Farranamartin, Tuam
Co. Galway
Stage 1
Road Safety Audit

Document Control Sheet

Document Reference	TR01 Road Safety Audit
Client:	Gilligan Consulting Engineers
Project Reference	12128

Figure 2-1 Right Turn Movement

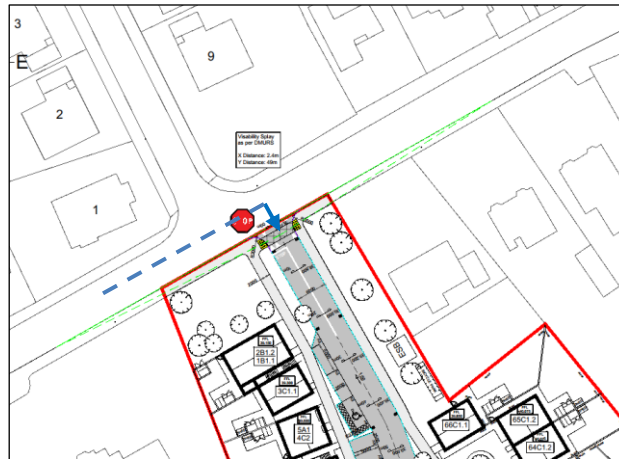
Right Turn Movements

The Audit Team observed onsite the existing environment along the R939 (Galway Road). The Audit Team are concerned about volume of traffic potentially turning right into the proposed estate. It may result in rear end collision(s) with stationary traffic wanting to turn right with approaching traffic.

The design team should ensure the planned traffic volumes don't require a queueing lane.

Figure 2-2 Ramp Details

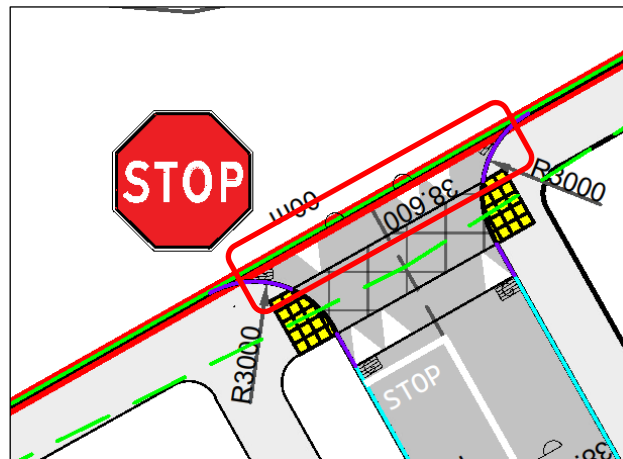
Ramp Details

The Audit Team noted on the design drawings the proposed raised table crossing and kerbing detail. The Audit Team are concerned that the proposed ramp will commence out on the carriageway, due to required kerb and gradient standard. This may result in road users striking the ramp edge and directing them towards other vehicles resulting in a head on collision

The design team should ensure the proposed raised table crossing meet the required standards.

Figure 2-5 Visibility Splay

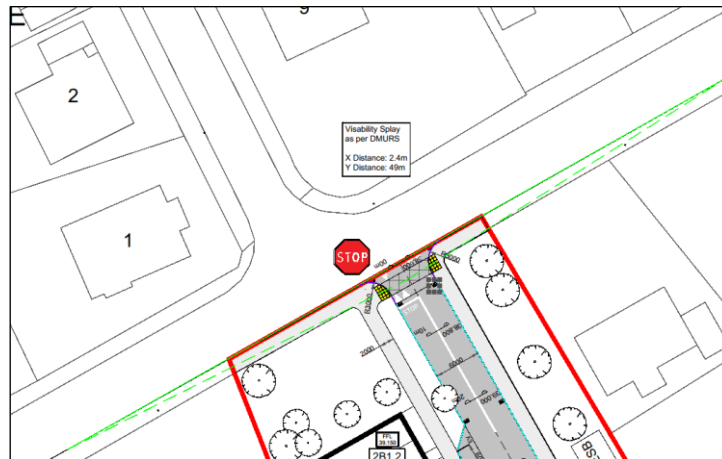
Visibility Splay

The Audit Team noted on the design drawings the visibility splay, at the proposed access. The Audit Team is concerned that the visibility splay shown are for vehicles on the pedestrian crossing, not at the STOP line. Inadequate visibility may result in vehicles entering the carriageway with oncoming vehicles, which may result in a side swipe type collision.

The design team should ensure visibility splay is provided as per standard.

Figure 3-2 Overhead Utility

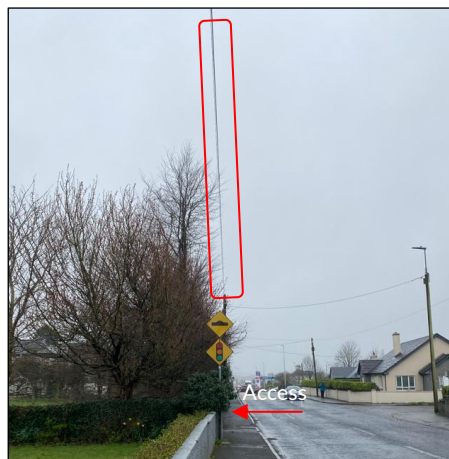
Overhead Utility

The Audit Team observed onsite the overhead utility wires at the existing field access.
